# CITY OF RAPID CITY

Ref: Oversize Request  
Plum Creek Subdivision Phase 2

The following is in response to your June 16, 2005 oversize request for Plum Creek Subdivision Phase 2. As discussed at our meeting of July 1, 2005 the following are the City's "concepts" on items that qualify for oversize reimbursement. The actual quantity and cost for oversize will be determined at a later date. The item numbers referenced below refer to the hand numbered items on the attached estimate you provided.

Figure 1  
Plum Creek Oversize Request

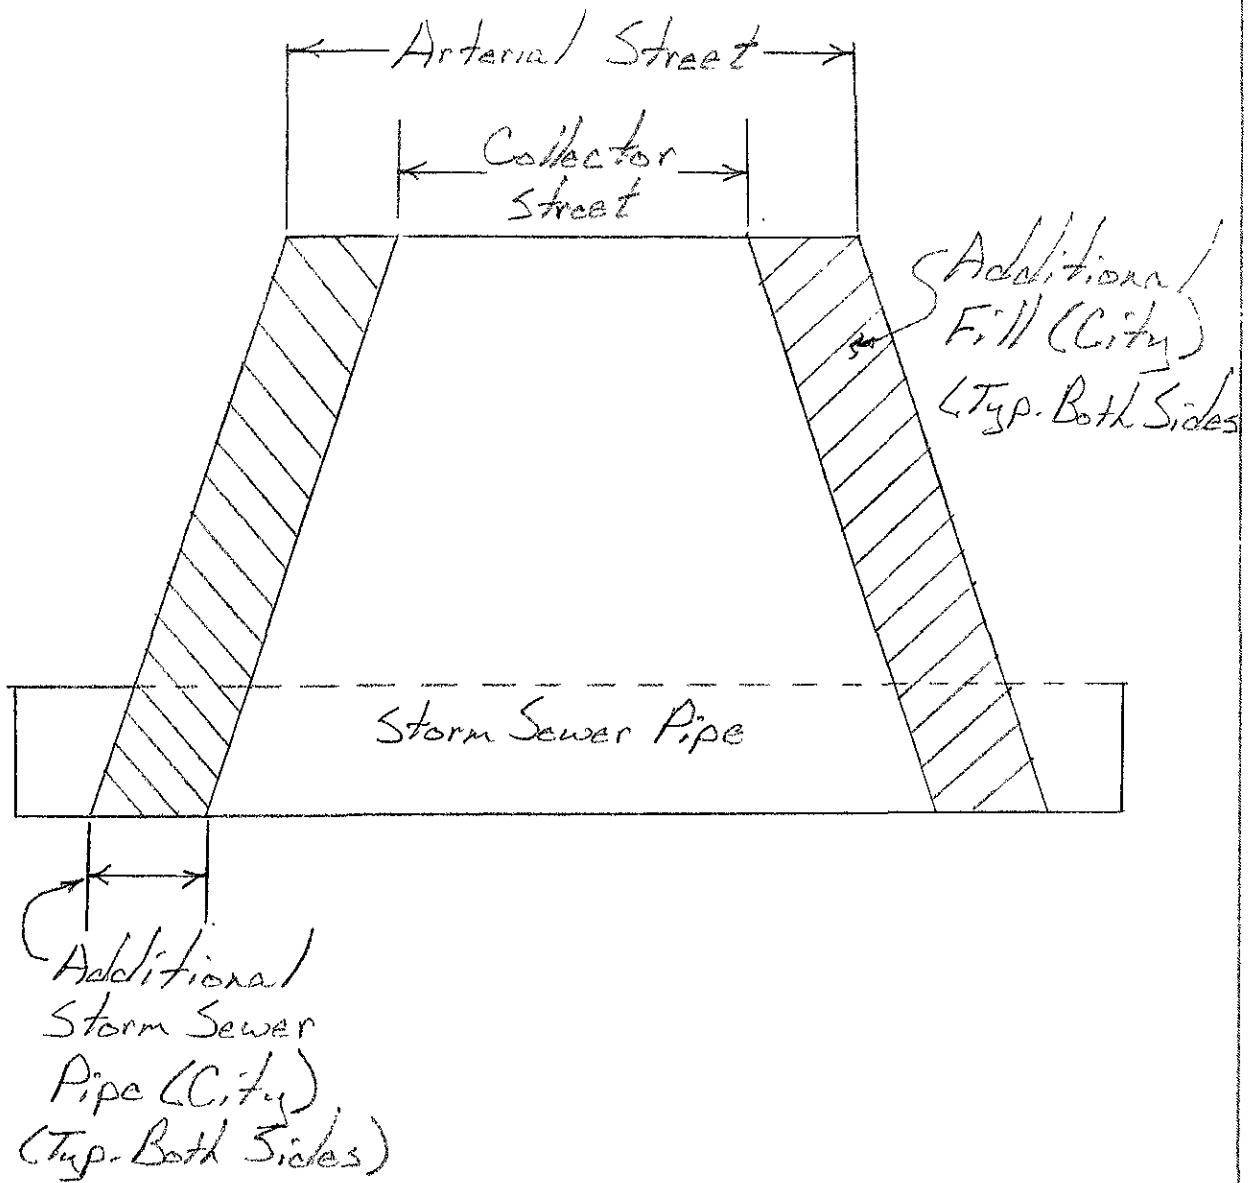
Item 2 – Unclassified Excavation – The City requests the roadway be graded to accommodate an arterial street. The City's obligation for unclassified excavation will be the additional fill material required to construct an arterial street vs. a collector street. See attached Figure 1.

Items 10 and 11 – Storm Sewer – The City's obligation will be for the increased length of storm sewer pipe needed to convey the storm sewer under the additional arterial roadway width. See Figure 1.
